# Technical Service Bulletin

**A/C BLOWS WARM AIR DUE TO REFRIGERANT LEAK FROM  
CONDENSER**

**Bulletin No.:** 07-001/18

**Last Issued:** 01/17/2018

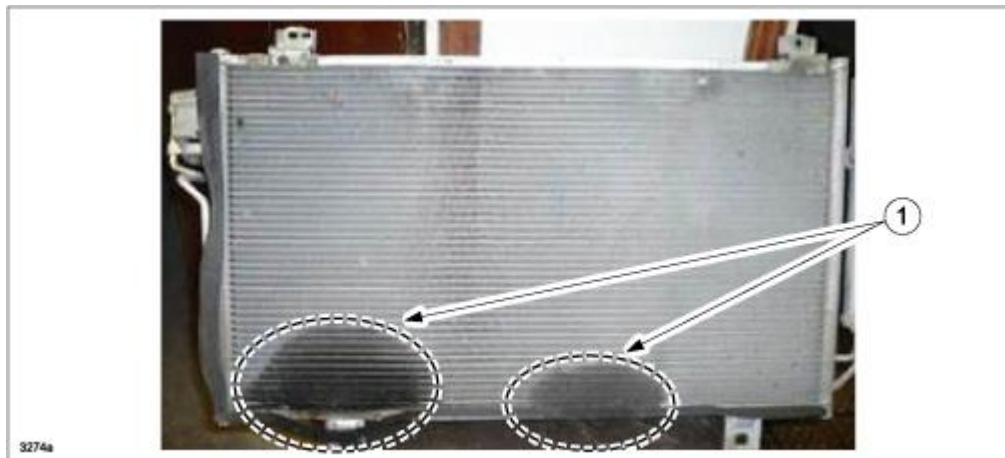
Some customers may complain about warm air from the climate control vents **when the air conditioner is ON**. This may be caused by condenser corrosion, causing a refrigerant leak.

**The manufacturer of the condenser has been changed and the configuration of the condenser tube has been improved.**

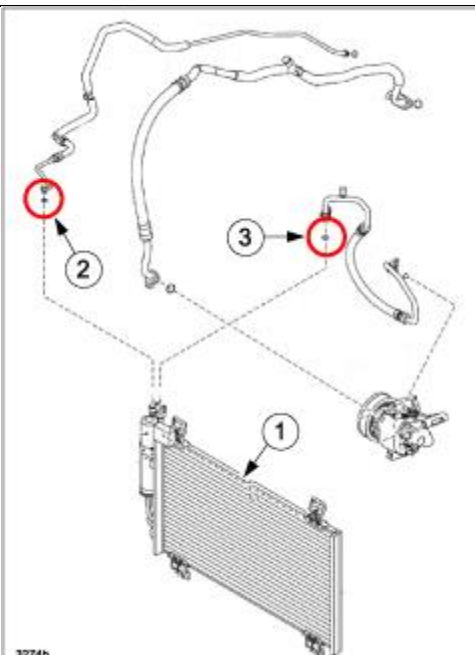
1. **Verify the customer concern.**
2. Visually inspect the condenser for A/C refrigerant leak.
  - Is there a visible trace of A/C refrigerant leaking at location (1)?

3. Use a dealer supplied UV leak detection tool. Is there a trace of fluorescent liquid at location (1)?

4. Replace the condenser **according to the instructions on MGSS online (CONDENSER REMOVAL/INSTALLATION [SKYACTIV-G 2.0])**.
